## Board of Zoning and Planning

### Staff Report

January 26, 2023 6:00 PM

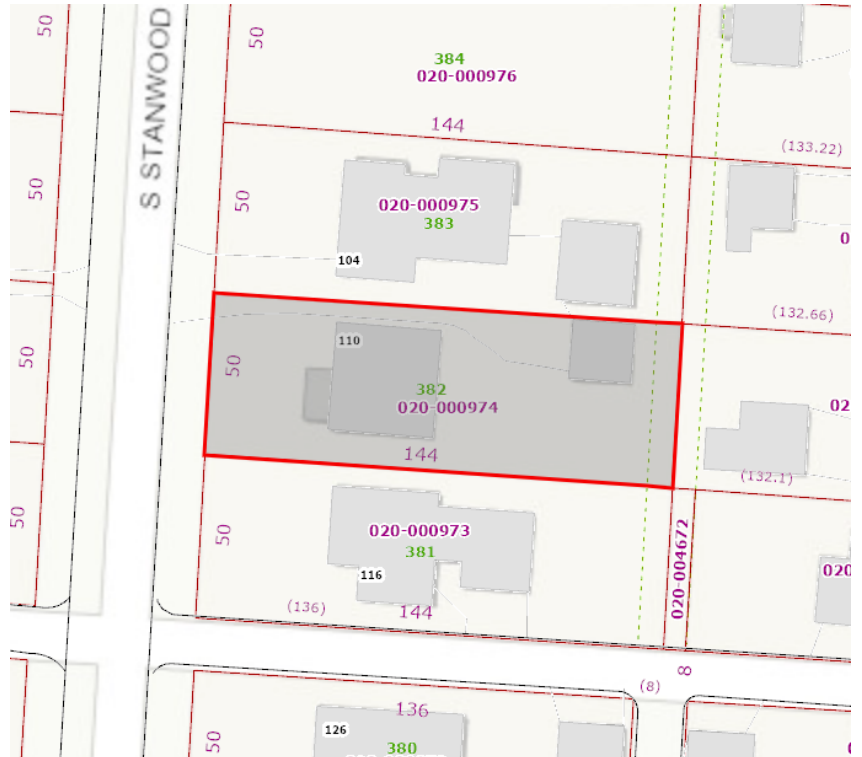
The applicant would like to replace the existing 18' x 18' detached garage which has a flat roof, is located 3' from the north side property line and 15.2' from the rear property line. There is also a shed located behind the garage. It currently encroached 4' into the 8' easement at the rear of the property.

The proposed 26' x 22' detached garage would accommodate 2 full parking spaces and some storage. Although it is encroaching 3' into the required setback from the easement, the

structure will not be within the easement where there is a city sanitary sewer. The new location of the garage is at the edge of the utility easement. Staff would like to point out that it is an improvement, based on the fact that the existing shed currently encroaches 4' into the easement.

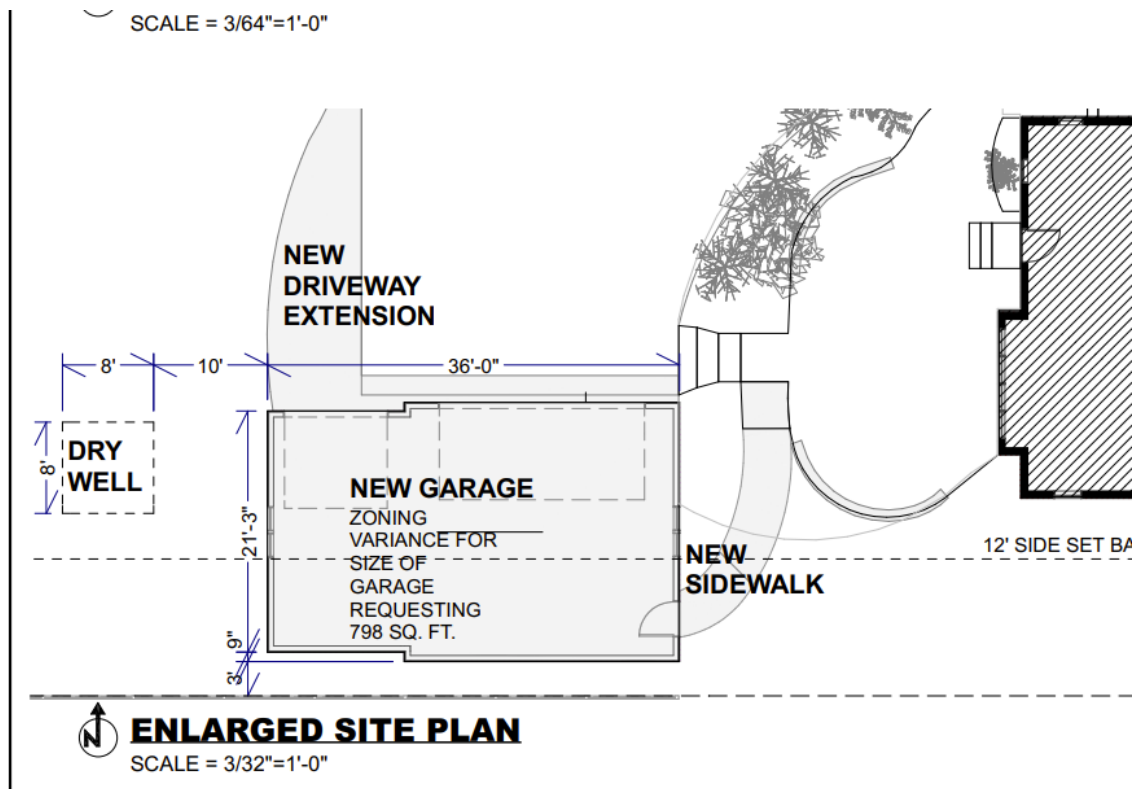
The Applicant was before the ARB Board and originally proposed the new garage 2' from the side property line. The Board advised the applicant to consider the 3' setback and the applicant has since modified the plans and will meet the 3' setback.

This lot is 17,731sq' and the proposed structure is 798sq'. The variance request is to allow the proposed garage to be 78sq' over the limit.

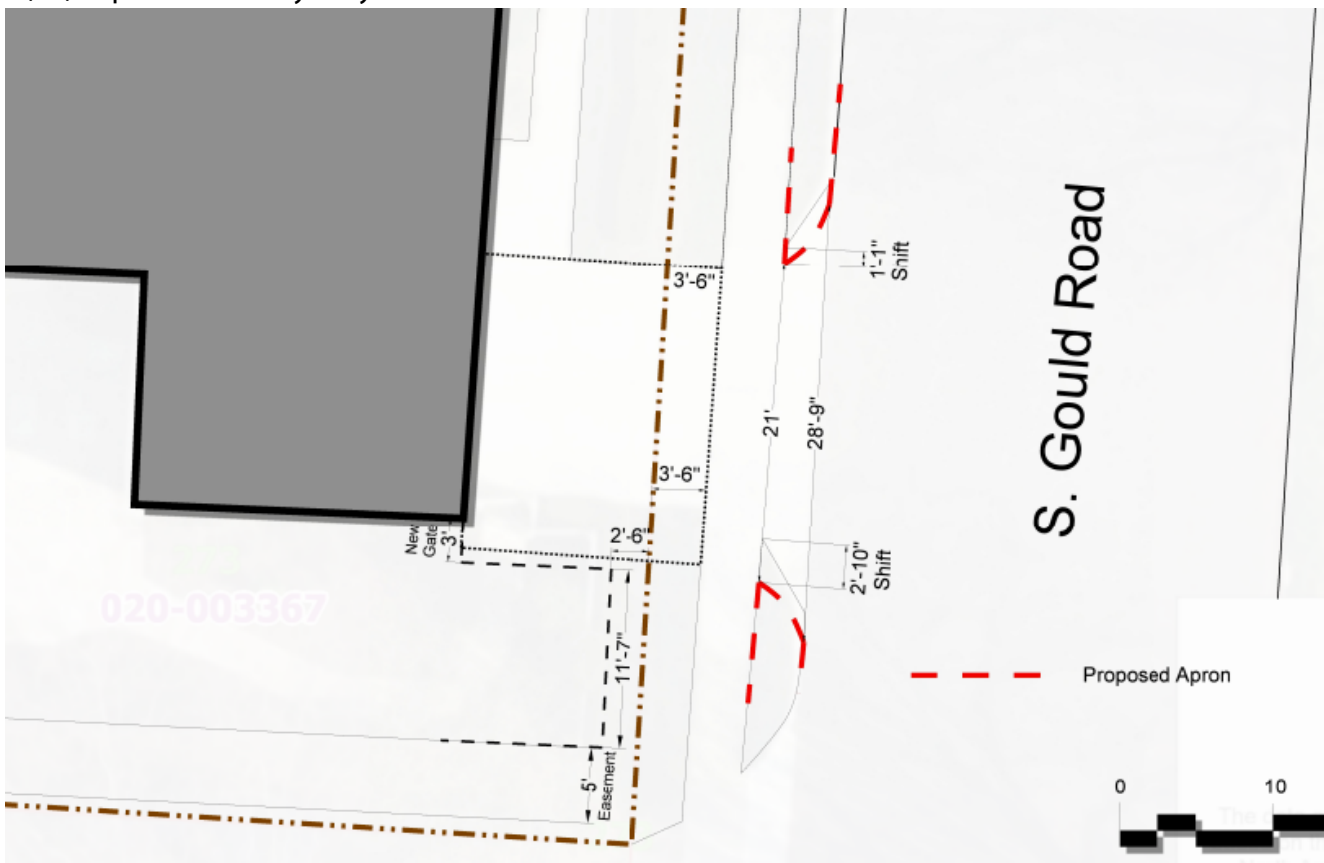
Bexley Code Section 1262.01(e) limits a driveway width to 12.5'. The existing driveway is 16' wide and lines up with the 16' wide garage door.

I have suggested just expanding the drive beyond the city sidewalk, but the applicant is interested in widening the approach as well.

(#1) Expand driveway only

(#2) Expand driveway and approach

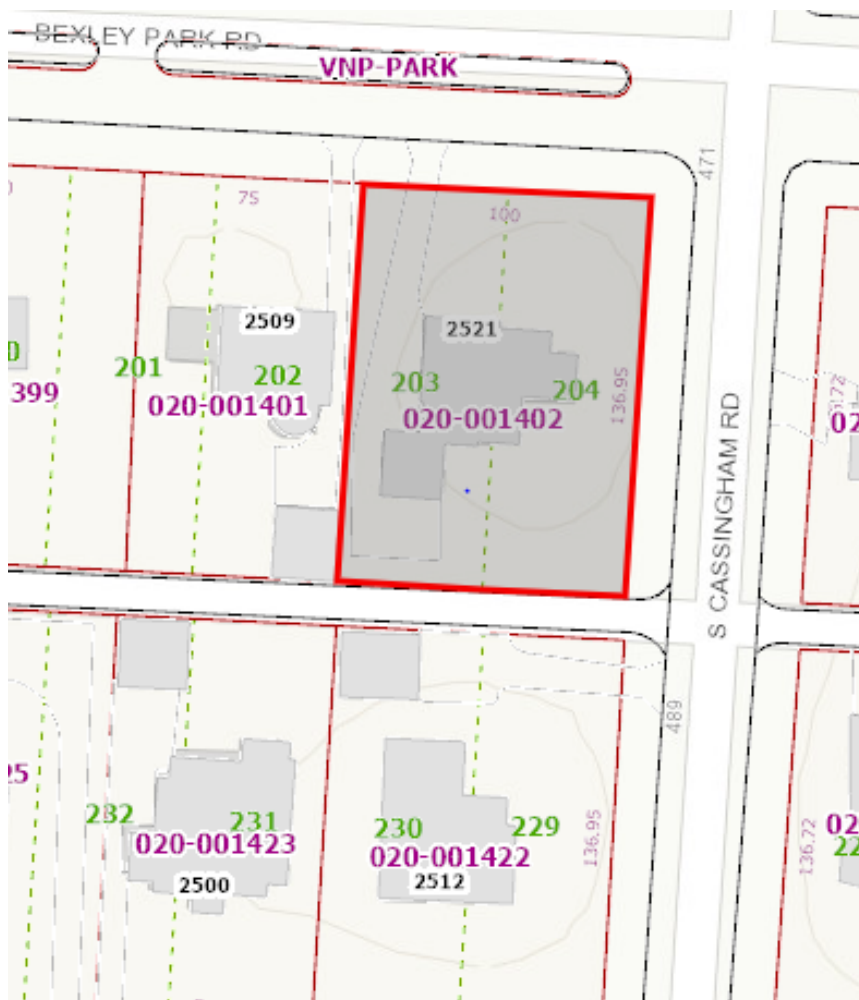
The idea is to center the pergola alongside the pool, which places the corner post of the pergola 20' away from the (east) side property line and the overhang of the pergola would be 17' from the east side property line.

The actual distance from the proposed pergola and the street curb is a little over 35'
